METROPOLITAN GOVERNMENT OF NASHVILLE AND DAVIDSON COUNTY

STAFF RECOMMENDATION
612 Monroe Street
February 19, 2014

Application: New construction-infill (Multiple Structures)
District: Germantown Historic Preservation Zoning Overlay
Council District: 19
Map and Parcel Number: 08209003400
Applicant: John Root, Architect
Project Lead: Sean Alexander, sean.alexander@nashville.gov

A1 SOUTH ELEVATION - UNIT 5

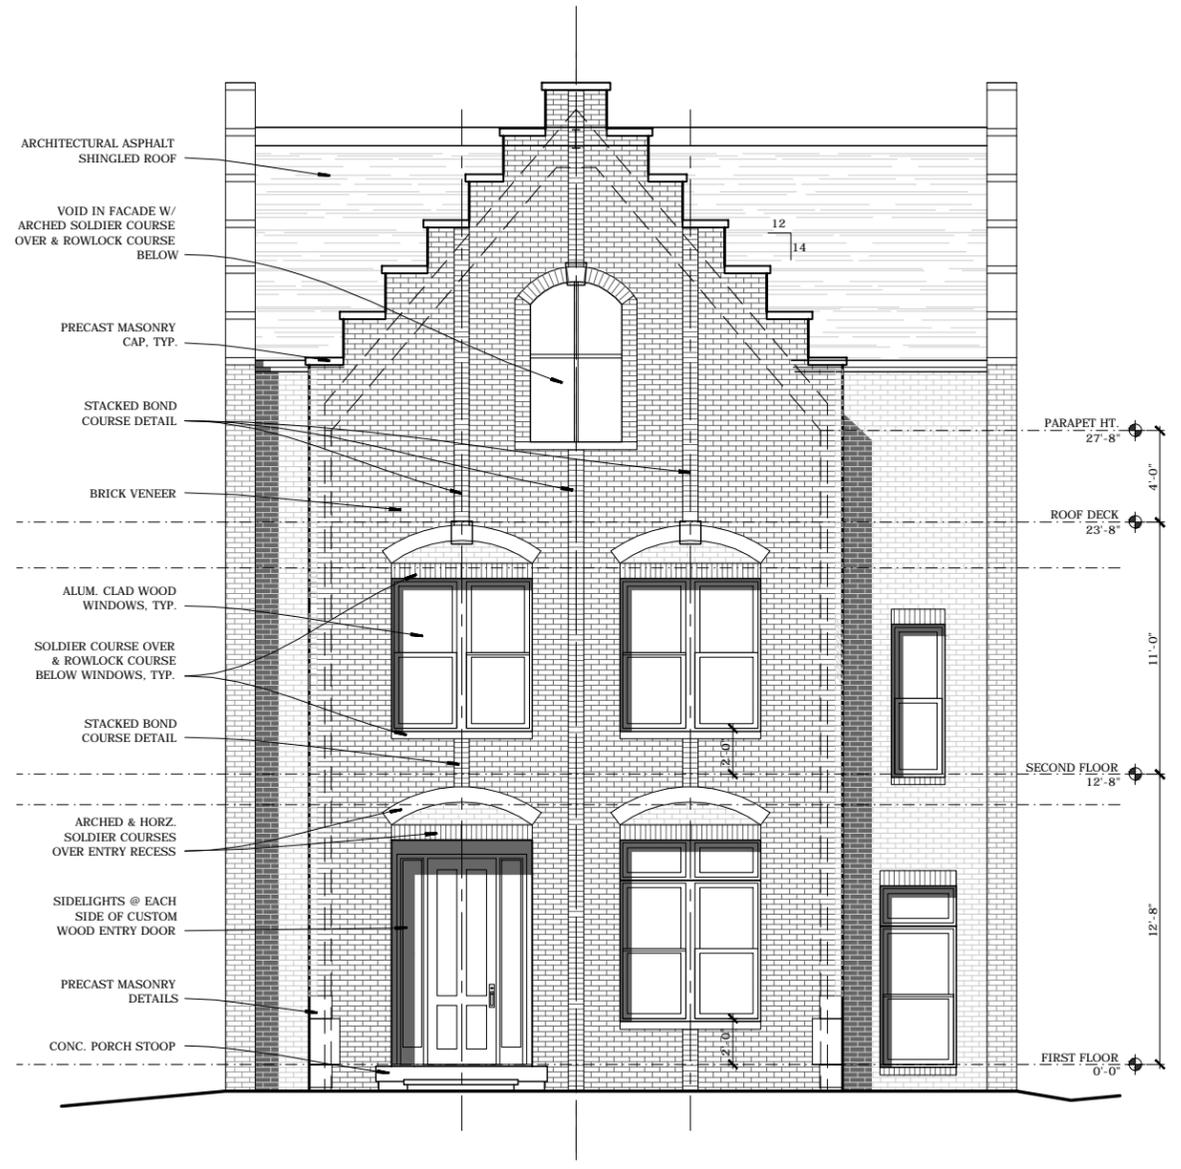
The roof on the corner building (Unit 5) would have the form of a cross-gable with stepped parapets, with a pair of Dutch gable wall dormers on the northern portion facing 7th Avenue North. Staff finds that while there are a wide variety of roof forms throughout the neighborhood in general, it is not common for a single structure to have incongruous roofs.

The southern and northern thirds of the roof will also be open. The open portion toward the southern end of the building, because it will be visible from the side as well as the front, will read unlike any historic roofs in the surrounding area. Staff recommends that, as a condition of approval, the roofs of the corner building (Unit 5) be revised to be more cohesive and that it not have an open slope in the corner component. The open roof section would be appropriate behind a gable or screen-wall as with other units. This will help to “anchor” the building to the two streets in a manner more in keeping with what is found on other corners in the neighborhood.

- Walkways be added to connect the building at the rear of the lot to the street;
- That the front doors be at least half glass;
- That windows are added to the side elevations of the single-family buildings (Units 1, 2, 8);
- That the roof of the corner building (Unit 5) be revised to be more cohesive and not open at the corner;
- The location of HVAC units and other utilities, as well as the material of the driveway and other paving, fences, walls, exterior lights, and other appurtenances are approved by Staff.
